OICA PROPOSED CORRIGENDUM TO TRANS/ECE/WP.29/GRPE/2008/6

Annex 4

Annex 4a, (based on ECE/TRANS/WP.29/GRPE/2007/8/Rev.1 as amended by Annex III of the report ECE/TRANS/WP.29/GRPE/55)

Paragraph 6.1.3, amend to read

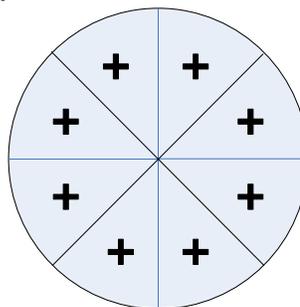
The above mentioned air velocity shall be determined as an averaged value of ~~9~~**a number of** measuring points which:

- **for blowers with rectangular outlets** are located at the centre of each rectangle dividing the whole of the blower outlet into 9 areas (dividing both horizontal and vertical sides of the blower outlet into 3 equal parts).

- **for circular blower outlets, the outlet shall be divided into 8 equal arcs by vertical, horizontal and 45° lines. The measurement points lie on the radial centre line of each arc (22.5°) at a radius of two thirds of the total (as shown in the diagram below).**

Each value at those ~~9~~points shall be within 10 per cent of the averaged value of themselves.

Paragraph 3.4.2., amend to read:

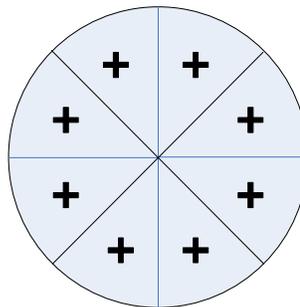
.....within ± 5 km/h of the corresponding roller speed ~~during the test cycle~~ **within the range of 10 km/h to 50 km/h. At the range over 50 km/h, the linear velocity of the air shall be within ± 10 km/h of the corresponding roller speed. At roller speeds of less than 10 km/h, air velocity may be zero.**

- for circular blower outlets, the outlet shall be divided into 8 equal arcs by vertical, horizontal and 45° lines. The measurement points lie on the radial centre line of each arc (22.5°) at a radius of two thirds of the total (as shown in the diagram below).
